Report: PRELIM TAB REPORT
Function: Test, Adjust, & Balance
Date: 11/12/2024
Completed By: National TAB

PROJECT
Warby Parker (Liberty Twp, OH)

Project Issue Information

1 MECHANICAL PLAN
SCALE: 1/4" = 1'-0"

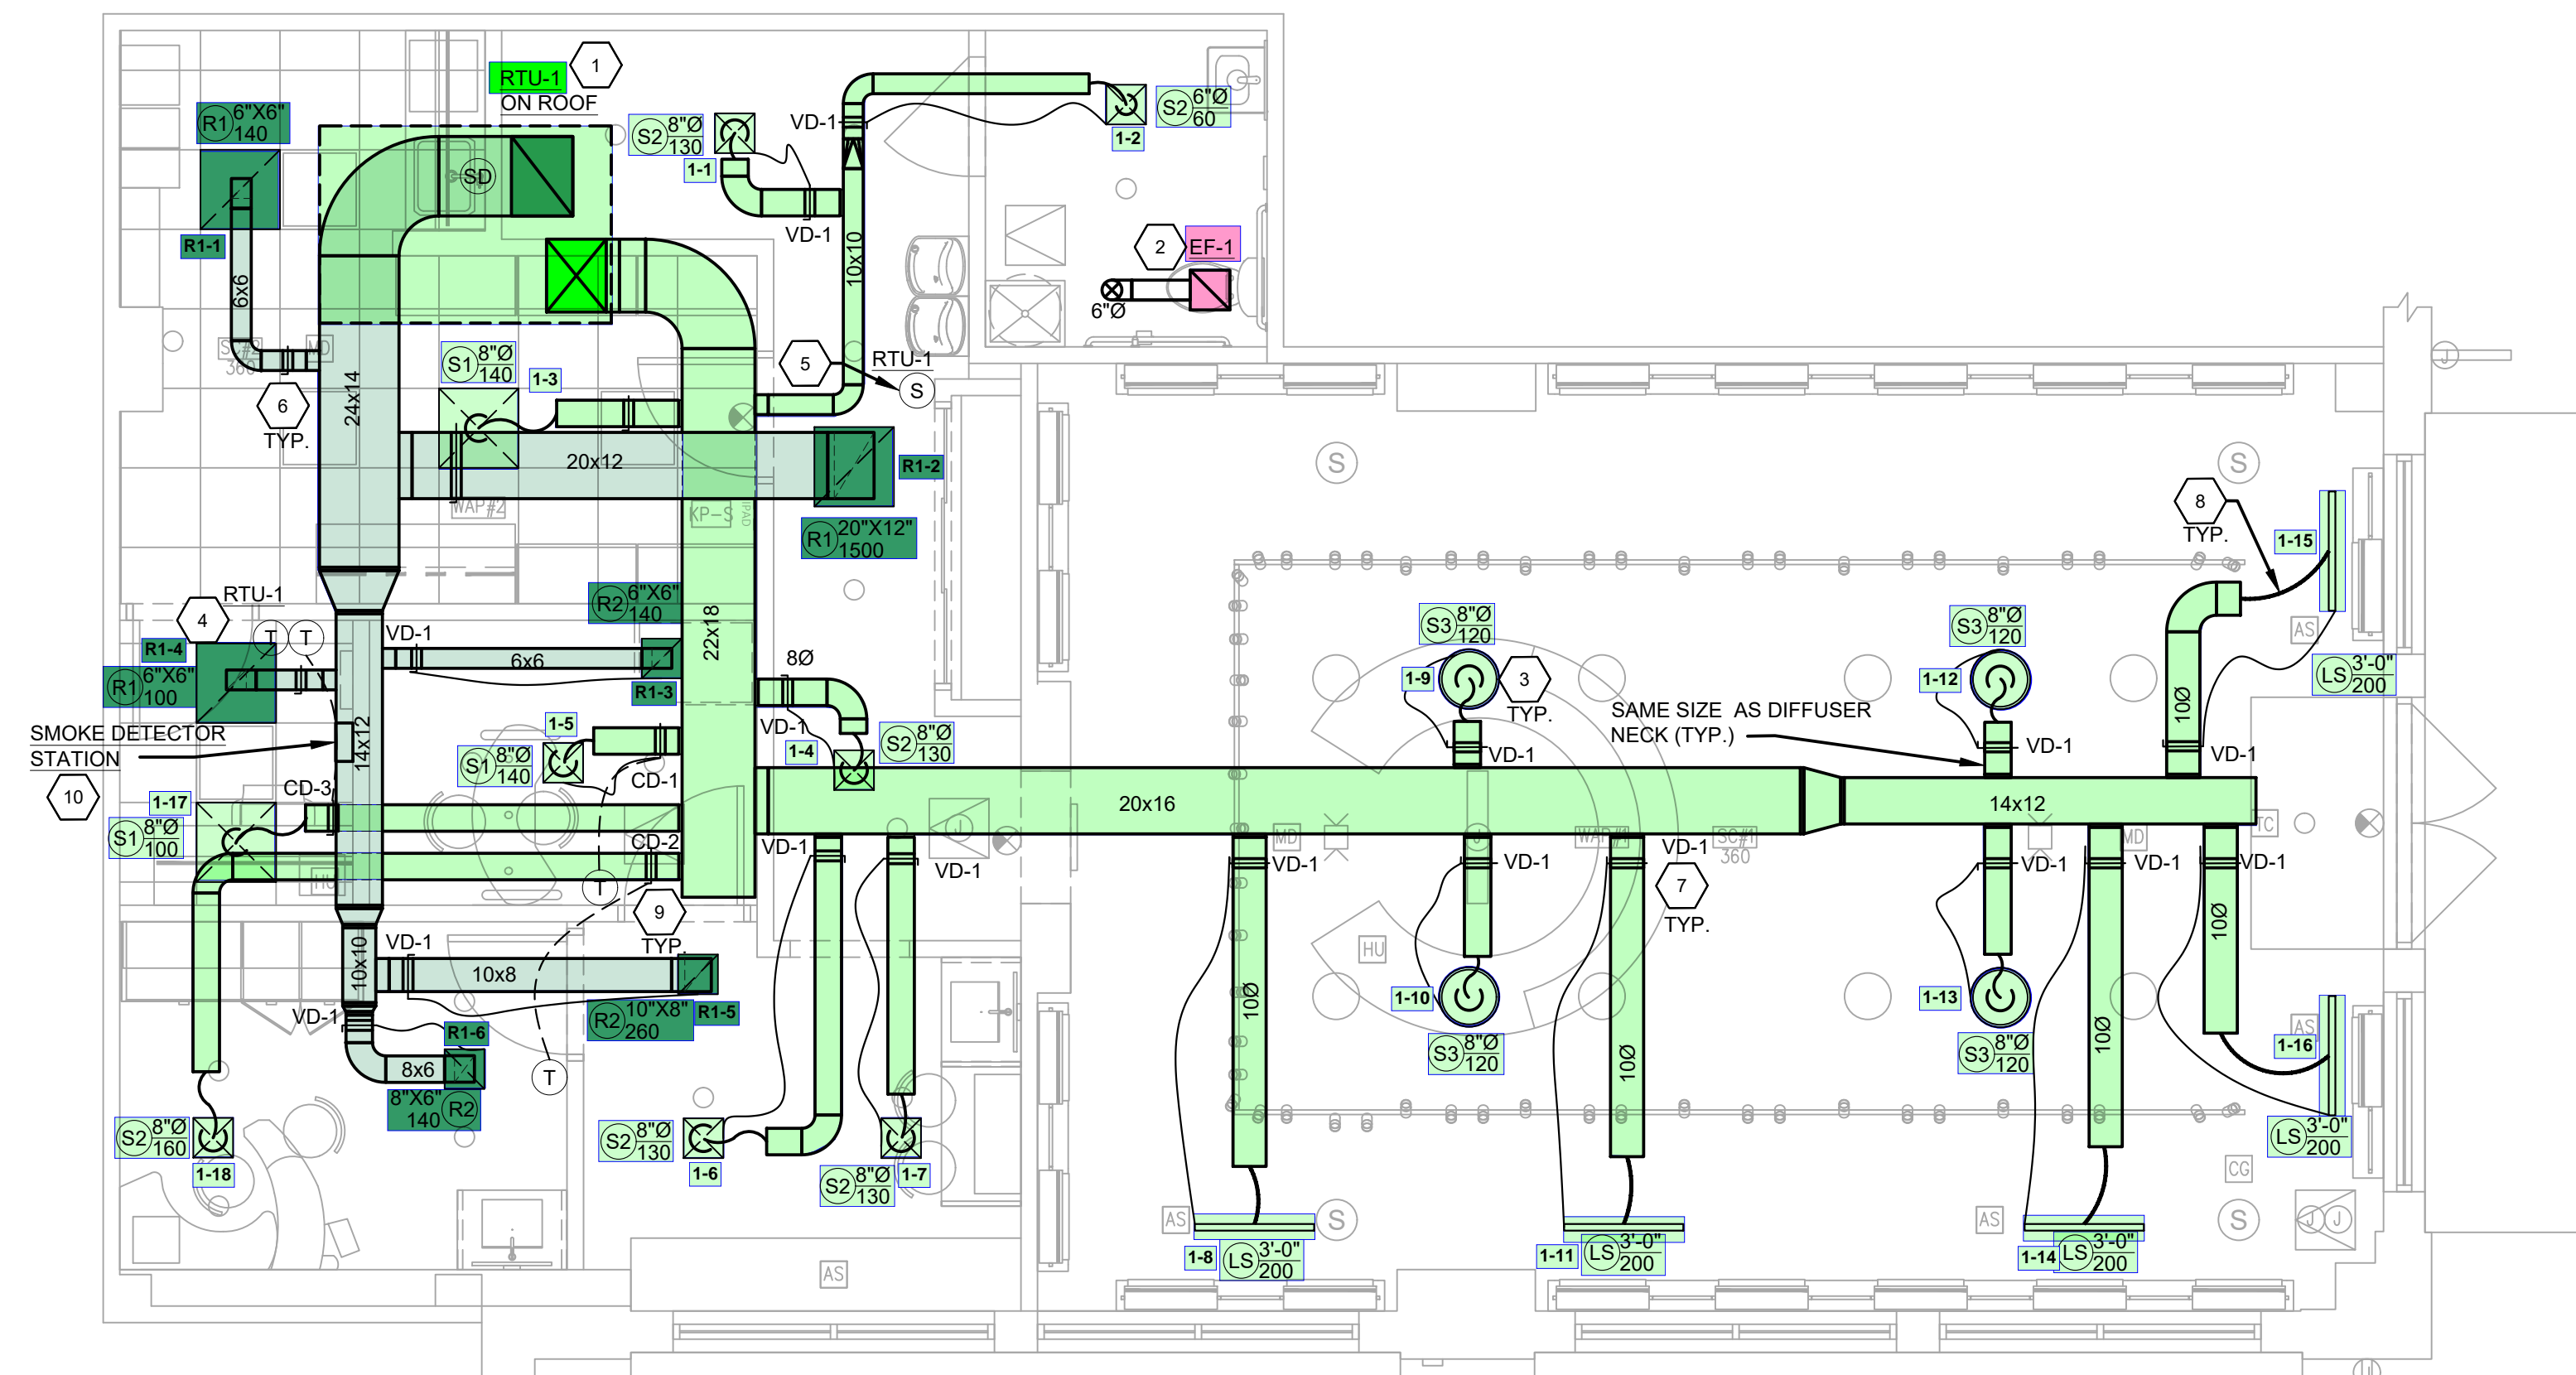
- Diffuser 1-3 missing damper.
- Loose flex duct connections.
- Motorized dampers cannot be controlled/balanced.
- RTU-1 Damper cables do not function or are broken.

Description : Motorized dampers operate independently in each room and fully open or close based on space demand and cannot be set to a specific position. Motorized dampers cannot be controlled/balanced for diffusers 1-5, 1-16, 1-17. Motors were temporarily disconnected and damper put in a fully open position for testing.

Description : Damper cables do not function or are broken on diffusers 1-1, 1-4, 1-6, 1-9, 1-13

Unit total flows are in design; diffusers were unable to be balanced due to a large amount of nonfunctional dampers.
